Topic	Lower and/or upper front suspension lever bushes - Warranty replacement guidelines
Market area	Bentley: worldwide (2WBE),China 796 VW Import Comp. Ltd (Vico), Beijing (6796)
Brand	Bentley
Transaction No.	2075041/4
Level	EH
Status	
Release date	16 Jul 2026

Lower and/or upper front suspension lever bushes - Warranty replacement guidelines

Figure 1

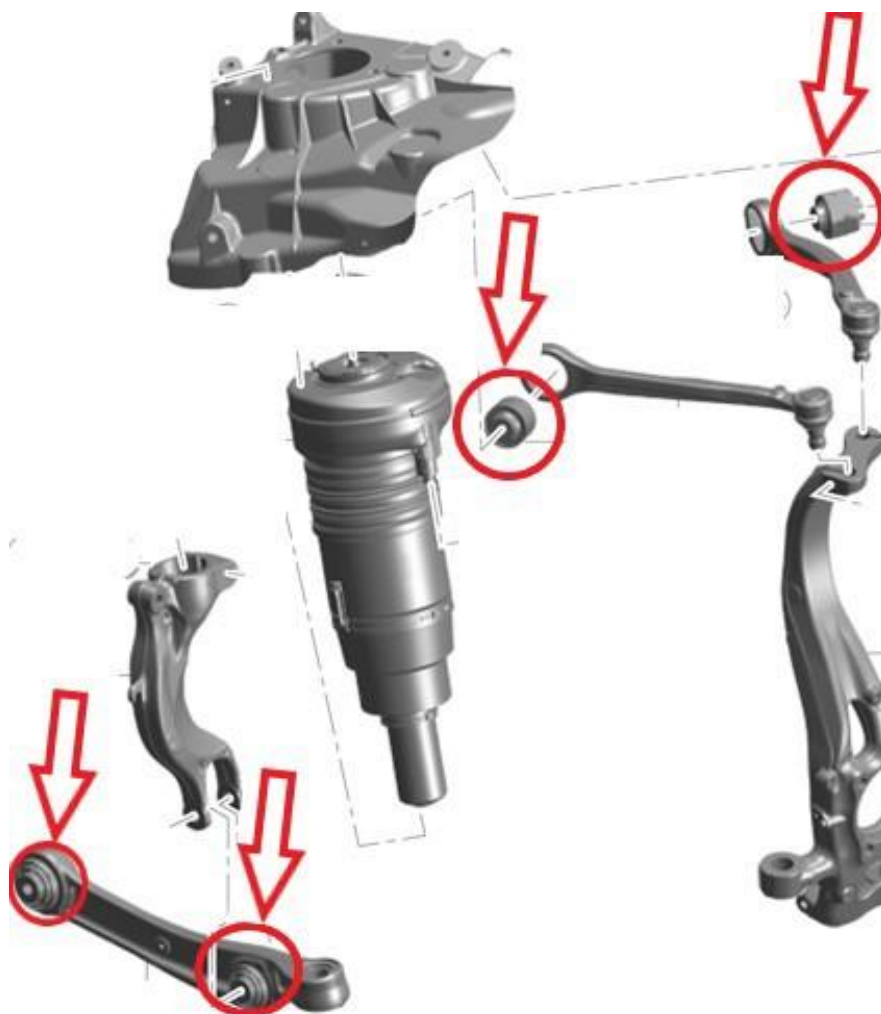
The left or right hand front lower and/or upper lever bushes (Figure 1) are exhibiting minor cracks (on inspection)

Before proceeding with replacing any of the lower and/or upper lever bushes shown in Figure 1 the operative must refer to the Technical background section of this TPI

Figure 4

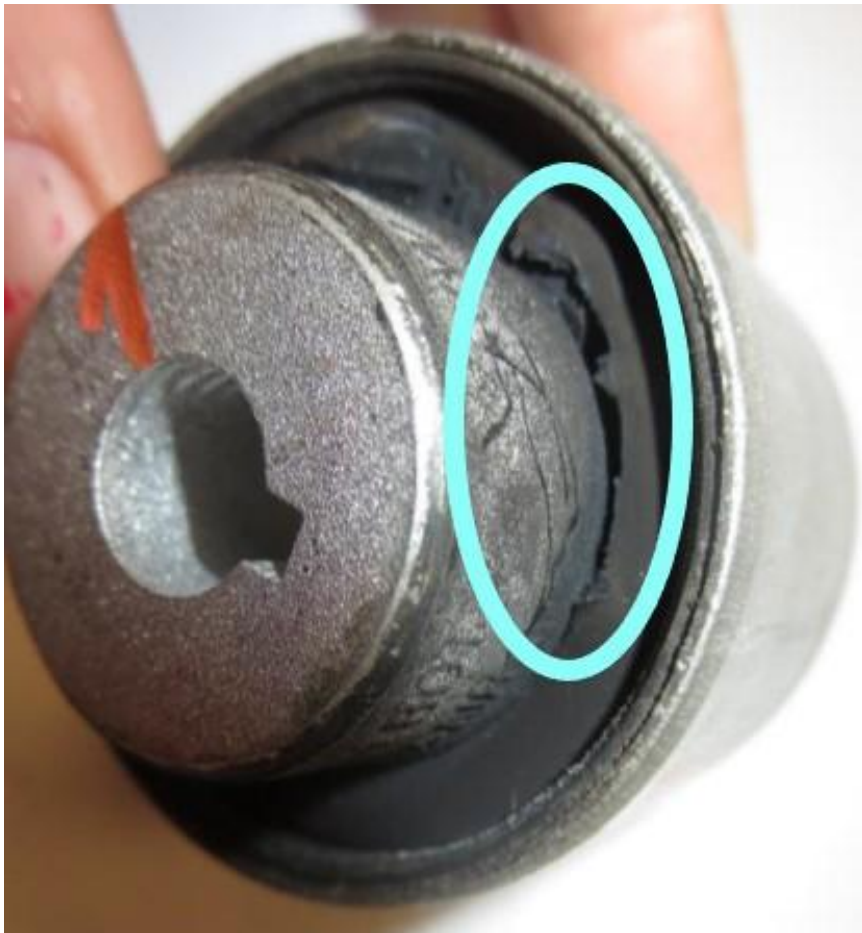
Should the bushes be in the condition shown in Figures 4, 5 or 6 - The bushes should be replaced as described within Rep.Gr 40

Please ensure photographs of all bushes (which require replacement) are attached to a non-technical DISS query. The warranty claim could be cancelled if the replacement criteria was not met
